COMMITTEE OF THE WHOLE JUNE 8, 2005

SITE DEVELOPMENT FILE DA.04.078
2748355 CANADA INC.

OPA 528 - Planned Road Network (Corporate Centre)

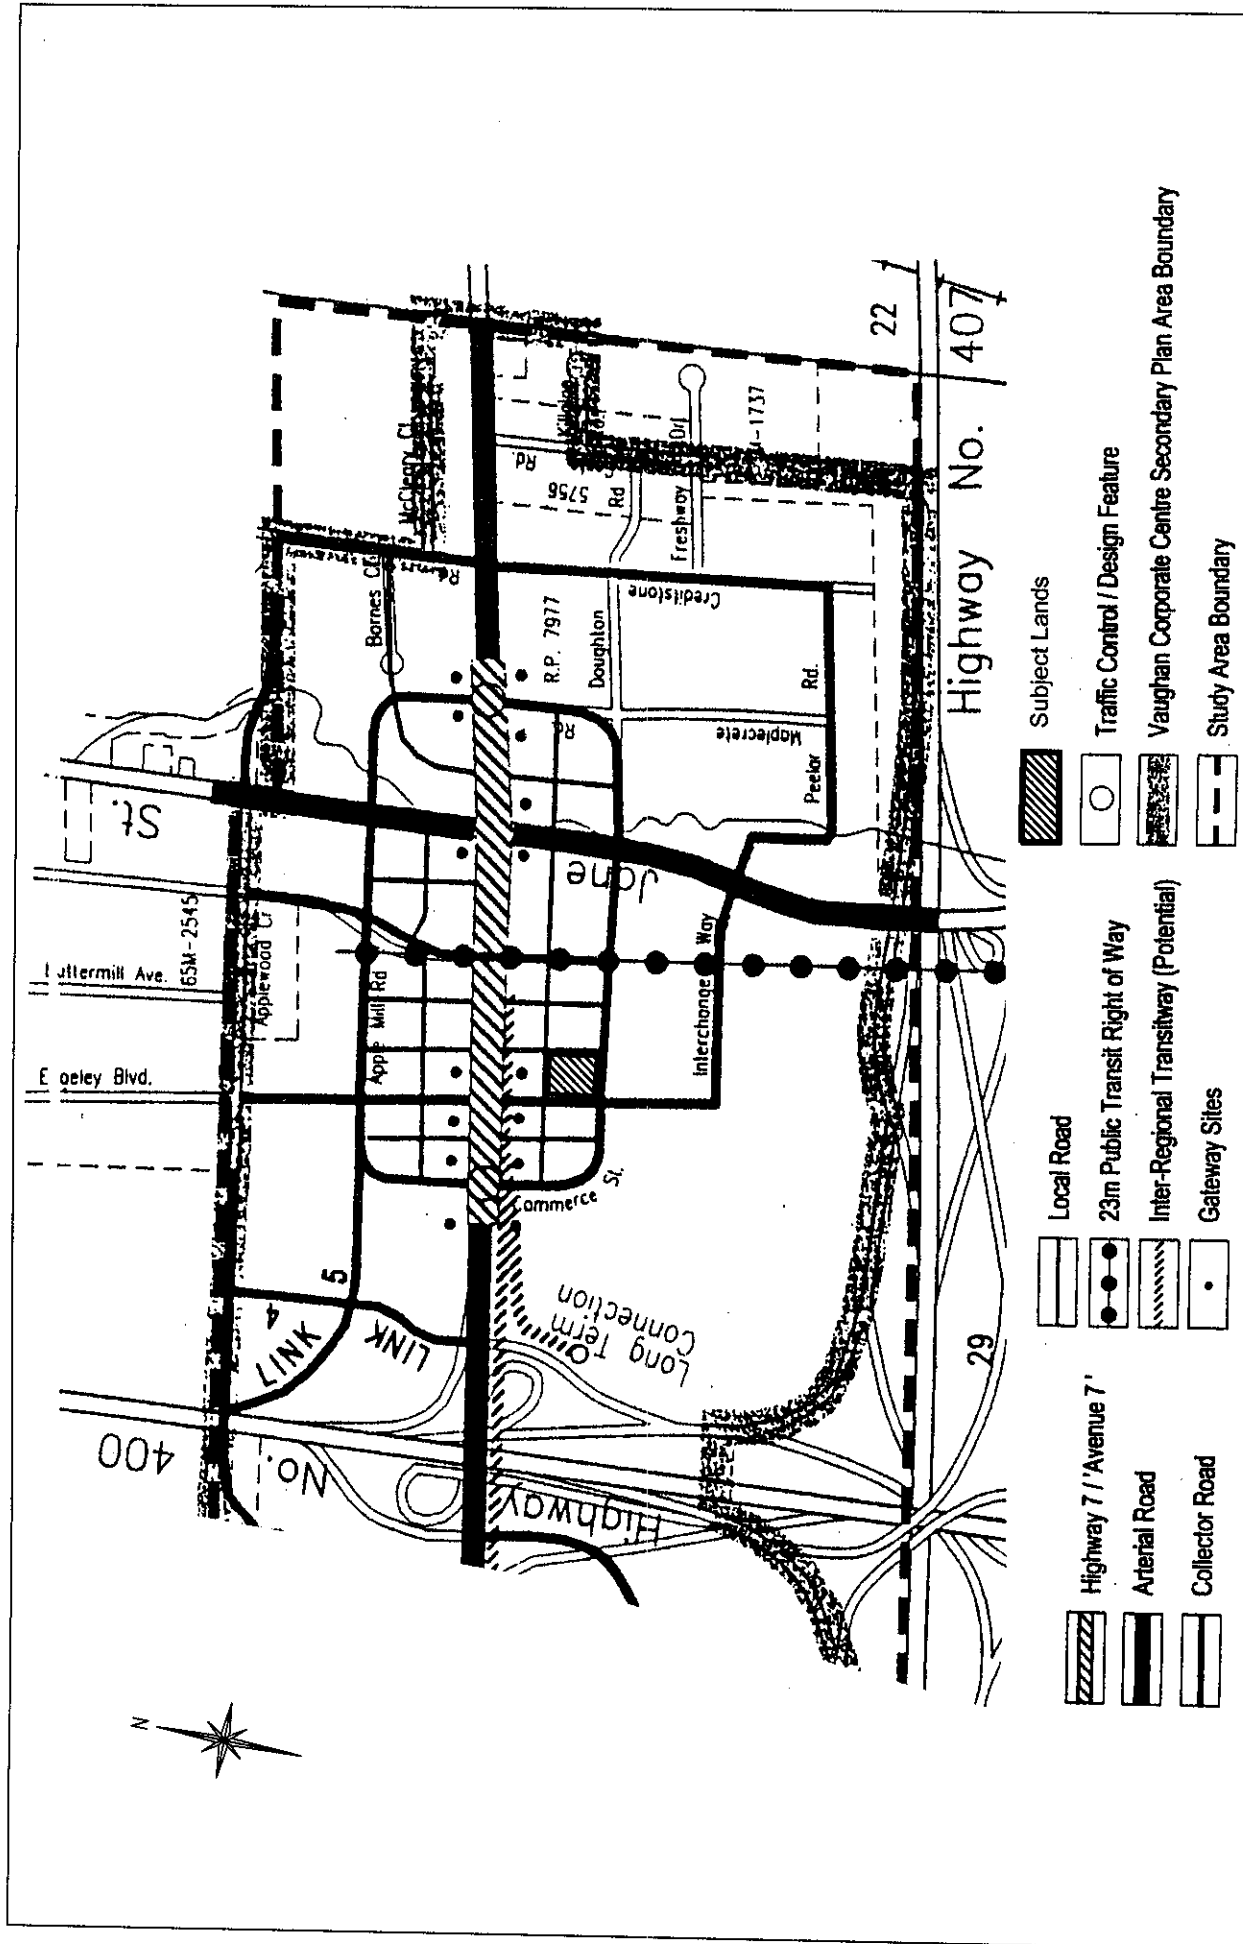
OPA #528 identifies specific road network improvements for the Corporate Centre Plan (Attachment #2). One of the elements of the plan includes a grid-pattern street system (100m x 100m) within the ring road. Two future roads, each having a planned width of 24m, are identified adjacent to the south and east property lines. To protect these future right-of-ways, there should be no encroachments of any structural elements along the respective property lines. The proposed building will not encroach into the future road locations.

The location of the proposed development relative to the planned road network for the Corporate Centre is shown on Attachment #2. OPA #528 identifies specific road network improvements serving the Vaughan Corporate Centre area (OPA #500). An east/west road (parallel to Regional Road 7) is planned to connect Commerce Street to Jane Street and beyond, across the south limit of the site plan. A north/south street is planned, connecting the ring road to the south of the site with Regional Road 7 to the north, just outside the east boundary of the site plan. The proposed building would not encroach into the planned roads.

Site Plan

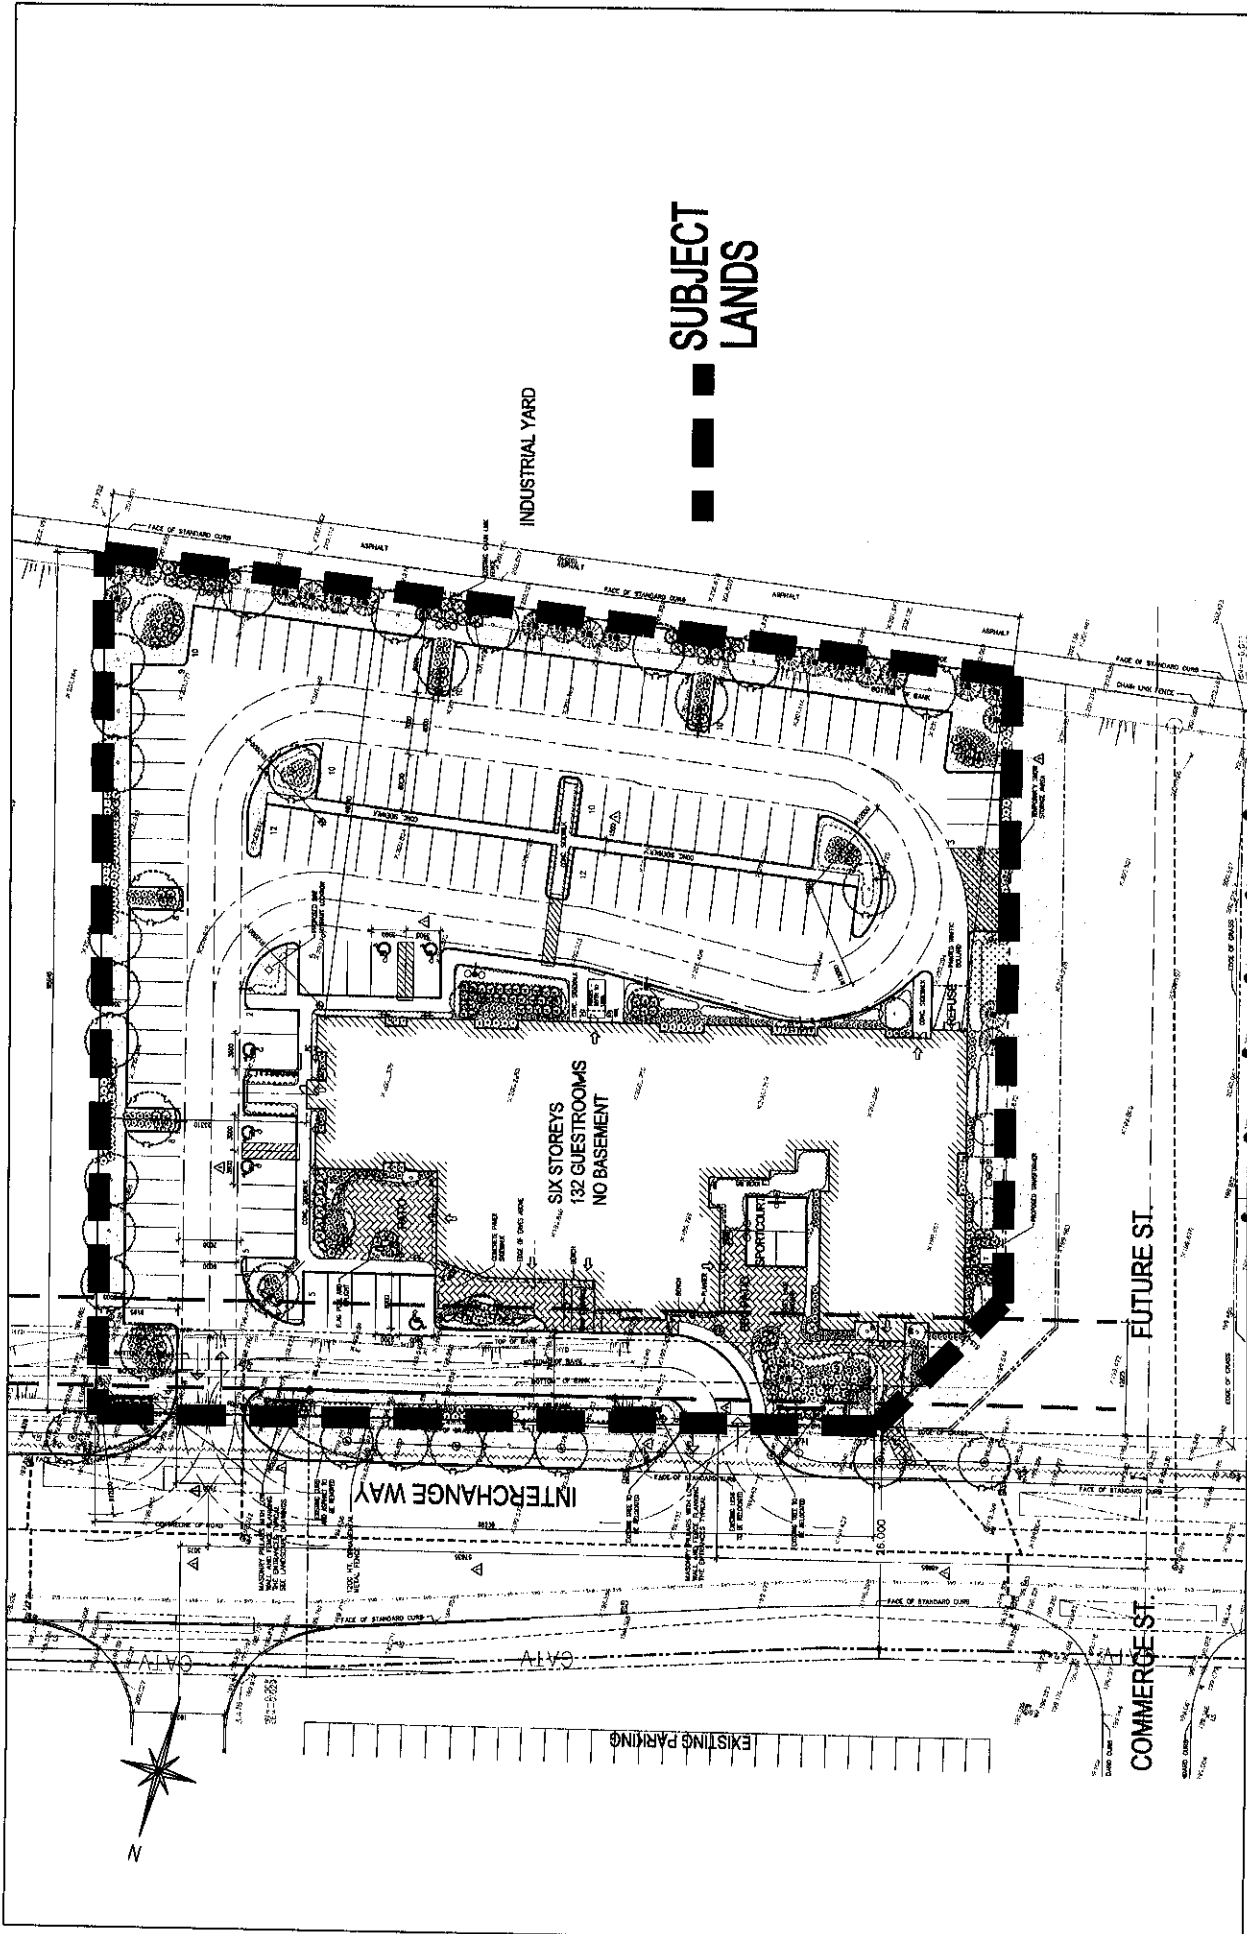
The site is subject to a build-to-zone provision, which requires 50% of the length of a street line to have a building located within 0-3m of Interchange Way and the future road along the southern property line. The proposed building is setback approximately 10m and 4.5m, respectively, from Interchange Way and the future southerly road, and 0.5m from the southwest corner of the

property. The hotel requires vehicular circulation, particularly for a customer drop-off/pick-up area adjacent to Interchange Way. This is an essential component for the hotel.

In the C9 Zone, By-law 1-88 requires a minimum 3m wide landscape strip along Interchange Way and a 6m wide landscape strip along the future road. The Owner proposes a 3m landscape strip along Interchange Way, and a landscape strip along the future road that ranges from a minimum of 1.07m to a maximum of 4.5m. Staff has no objection to the latter reduction to 1.07m, which is restricted to a short stretch located south of the parking area.

The Owner is proposing no loading spaces for the entire development. By-law 1-88 requires two loading spaces for commercial buildings between 2501m² - 10,000m² of gross floor area. The Owner has indicated that a loading door is not required for the operation of the hotel. Staff has no objection to the absence of a loading area, particularly in the context of the Corporate Centre, which is a highly visible location.

The site plan (Attachment #3) shows a six-storey hotel, with an outdoor sports court and patio facing Interchange Way. The site is served by a drop-off/pick-up layby with two full accesses onto Interchange Way. There is vehicular circulation with parking at the north and east sides of the building. Landscaping and pedestrian walkways are proposed around building with a connection to Interchange Way. Garbage storage is internal to the building.

Two full-movement accesses are proposed onto Interchange Way. The Engineering Department requires a traffic study to address the impact on the intersection of Interchange Way and Regional Road 7. The Owner has submitted a traffic study jointly with the owner of the lands to the north, also proposing a hotel, (Hilton Garden Inn - DA.04.073). As a condition of site plan approval, the traffic study must be to the satisfaction of the Region of York Transportation and Works Department and the Engineering Department.

1. THAT Site Development File DA.04.078 (2748355 Canada Inc.) BE APPROVED, to permit a six-storey hotel (Marriott Residence Inn), with 132 guestrooms, a sports court and outdoor patio, as shown on Attachment #3, subject to the following conditions:

- a) the prior to the registration of the site plan agreement:
 - i) the final site plan, building elevations, landscaping and signage plans shall be approved by the Development Planning Department;

- ii) the final site grading and servicing plans, stormwater management report, access, parking and on-site vehicular circulation, shall be approved by the Engineering Department;

- v) all hydro requirements of Power Stream Inc. shall be satisfied;
 - vi) the required variances to implement the final site plan shall be approved by the Committee of Adjustment to address the reductions to the build-to-zone, landscape strips and loading spaces, and such variances shall be final and binding; and,

Landscape Plan

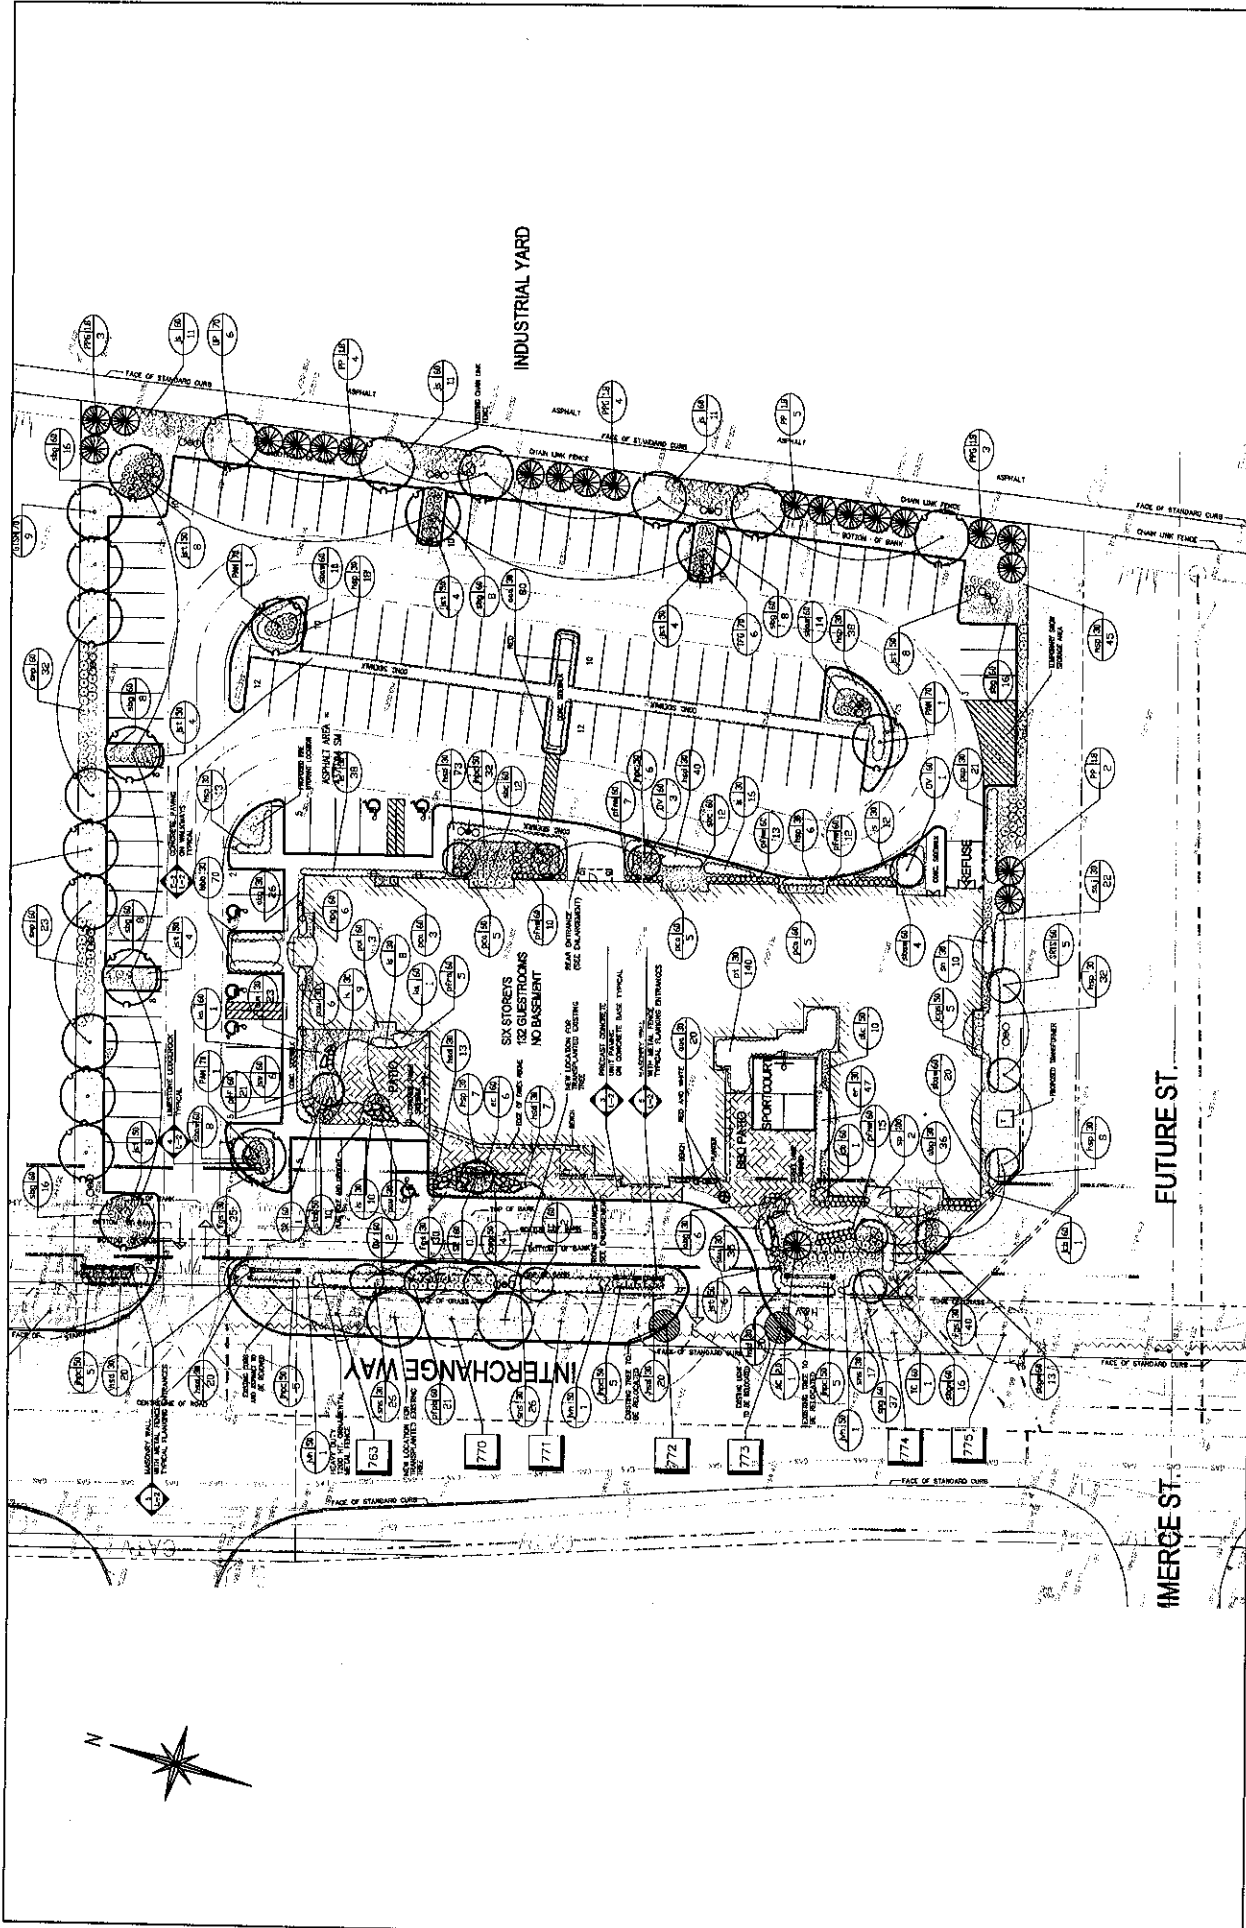
The proposed landscape plan (Attachment #4) shows a variety of deciduous and coniferous trees and shrubs around the perimeter of the site, abutting the proposed Hilton Hotel, and within the parking area. Interchange Way is heavily planted, and includes four masonry pillars with a fence flanking both access points. A wide pedestrian walkway consisting of concrete pavers, landscaped with trees and shrubs is proposed along the west elevation, connecting the main entry to both the patios and Interchange Way. The walkway narrows to 1.7m as it continues around the building connecting to the northerly and easterly parking areas. The final landscape plan, including detail drawings and a landscape cost estimate must be approved to the satisfaction of the Development Planning Department.

Elevations

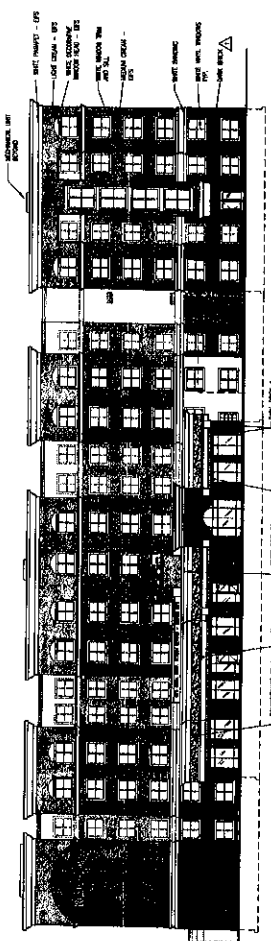
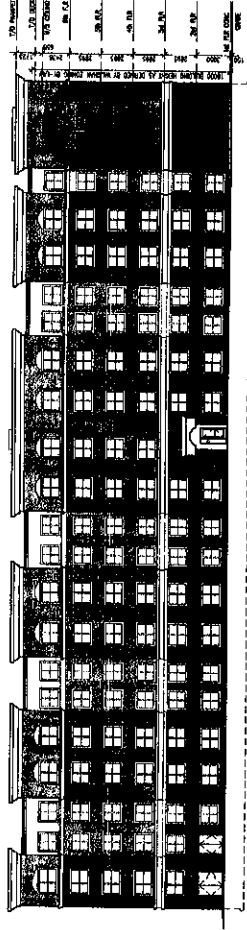
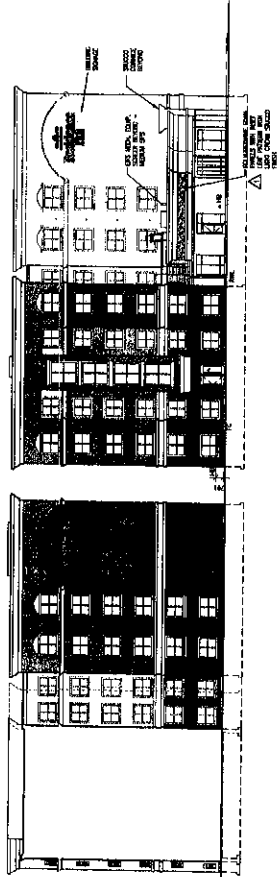
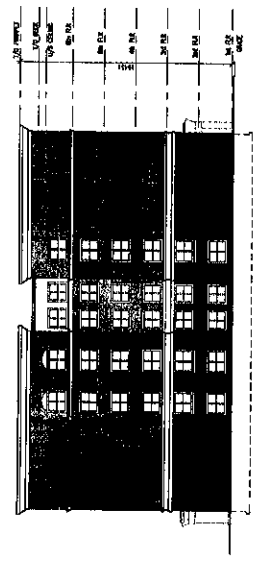
The proposed building elevations are shown on Attachment #5. The 6-storey building will be constructed to a height of 18m. The building materials consist of glass windows, white cornice and trim and a brown brick base for the first and second floors, a medium cream stucco for floors 3-5, and light cream stucco for the sixth floor. The main entry is located on the west elevation facing Interchange Way, with a single door framed by a square-shaped entry feature. Each floor has a series of square windows framed in white trim, along with a white cornice trim between the second and third, and fifth and sixth floors, respectively. Three of seven additional doors provide access to the northerly and easterly parking areas, with the remaining four granting access to the patio, sports court and pathways connecting to Interchange Way. The roofline is trimmed with a white stucco cornice and all mechanical equipment will be screened from the view of the adjacent street.
